Agenda – East Kildonan-Transcona Community Committee – September 3, 2026

Item No. 4 Variance – 513 Pandora Avenue West
(Transcona Ward)
File DAV 133682/2026D [c/r DAZ 211/2026 and DCU 133692/2026]

Title: DAV 26-133682/D – 513 Pandora Avenue West

Issue: For consideration of a Variance for a multi-family dwelling (8 units).

Exhibit “6” referred to in File DAV 133682/2026D

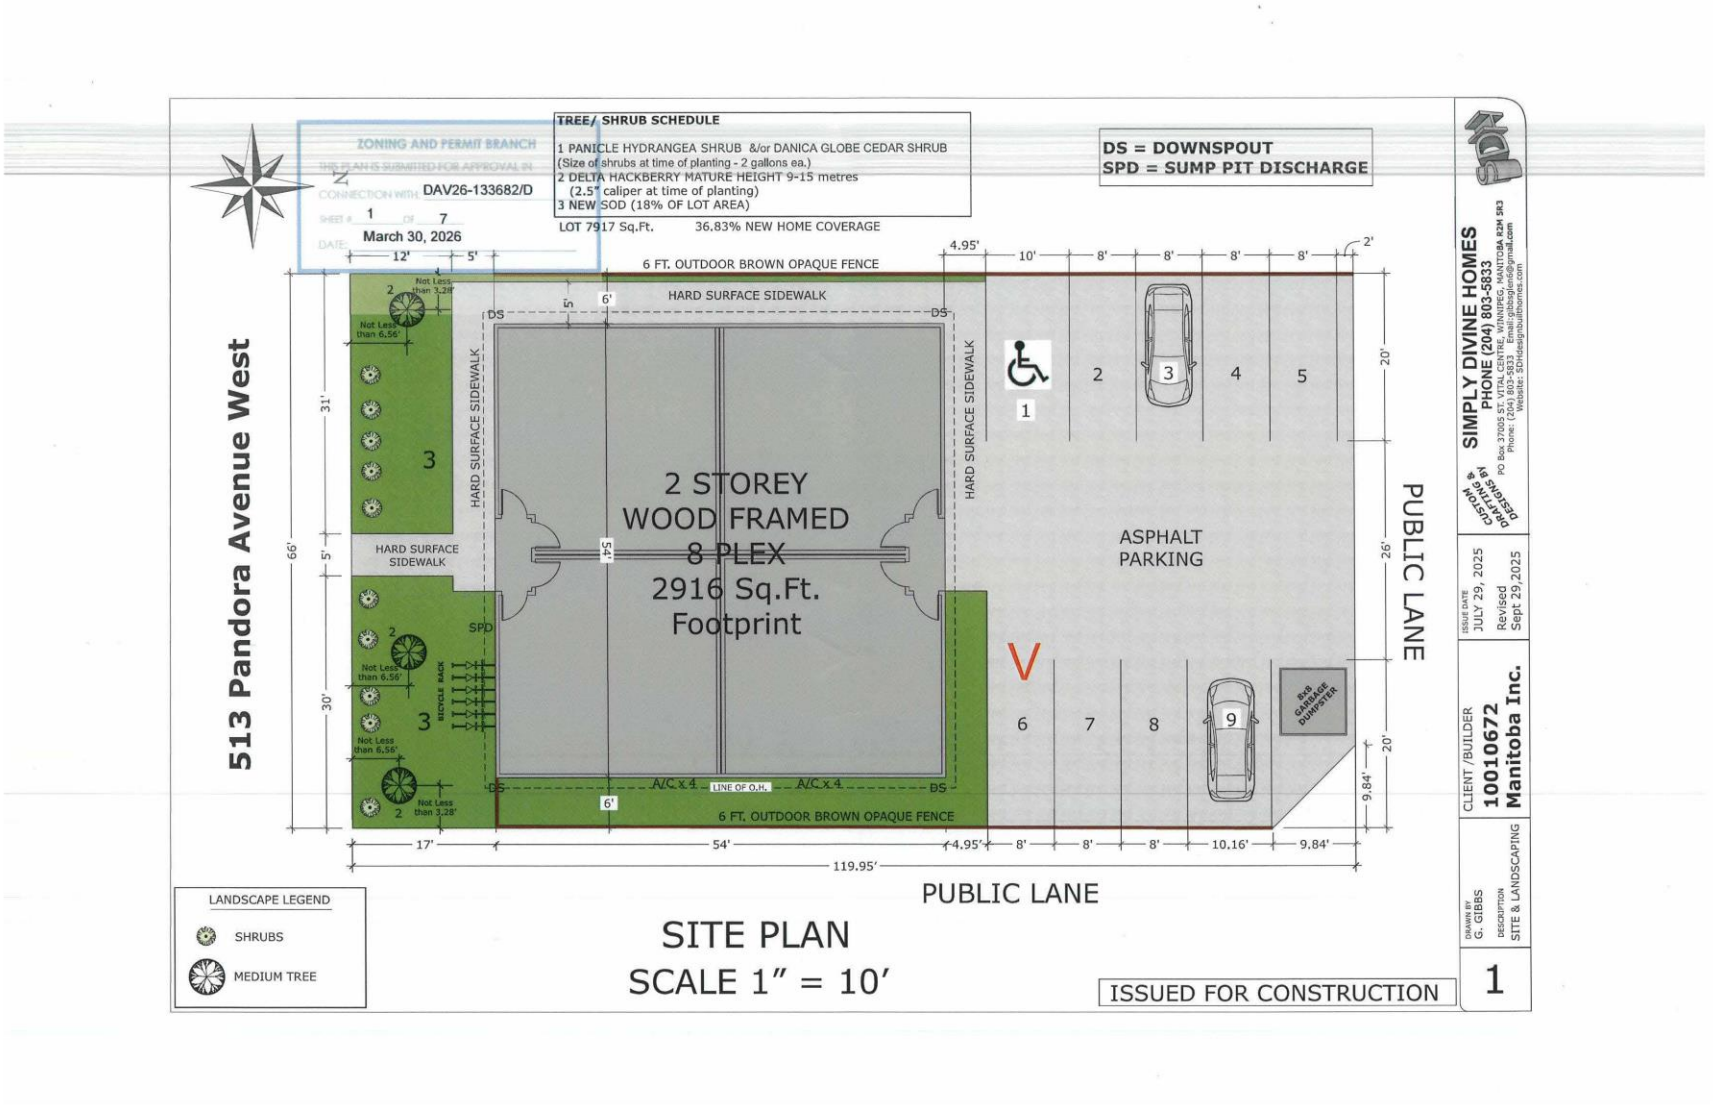
- Vehicular access to the property is proposed to remain via the concrete rear public lane.
- The site plan shows street edge plantings totaling three (3) trees and ten (10) shrubs. No building foundation landscaping is provided.
- The façade of the building features Hardie siding, wood looking metal plank, acrylic stucco and traditional stucco as the primary cladding materials.
- The proposed development requires that the subject property be rezoned from "R1-M Mature Communities PDO-1" Residential Single-Family (Medium) District to "R2 Mature Communities PDO-1" Residential Two-Family District (see planner's report for DAZ 211-2026).
- The proposed development requires Conditional Use approval for the establishment of a Multi-Family Dwelling (8 units) use (see planner's report for DCU 26-133692/D).

- As per the Landscaping provisions in the *Infill Guidelines*, a minimum of 20% of the lot area should be reserved for soft landscaping. The proposed development has 18% of the lot area dedicated to soft landscaping, therefore not complying with the *Infill Guidelines*.

- As per the Utilities provisions in the *Infill Guidelines*, HVAC units and other ventilation equipment should be located in the building, on the roof, or at the rear of the property. The proposed development has AC units on the side of the building, therefore not complying with the *Infill Guidelines*.

- The *Winnipeg Zoning By-law* requires building foundation landscaping for all principal buildings outside of the Urban Infill Areas (section 190.5). The applicant is not proposing any building foundation landscaping; therefore, a Variance is required to proceed.

- The *Winnipeg Zoning By-law* requires a landscaped buffer when a parking area is within 20 feet of a rear lot line adjacent to a residential zoning district (section 190.8). The applicant is proposing a parking area abutting and accessed from the rear public lane. Therefore, a Variance is required to proceed.

- In review of the site plan for the proposed multi-family dwelling, it appears the applicant could meet the building foundation landscaping requirement. Additionally, *CCDS 2.0* encourages a high standard of urban design for new development in Mature Communities. For these reasons, the Urban Planning and Design Division does not support this Variance.

- A buffered parking area would create no greater privacy to the residential lots than what already exists with the rear lane adjacent to the rear lot lines. For this reason, the Urban Planning and Design Division supports this Variance.

In order for the proposed development to comply with the *Infill Guidelines*, Plan Approval will be recommended as a condition of approval for the associated file (DAZ 211/2026).
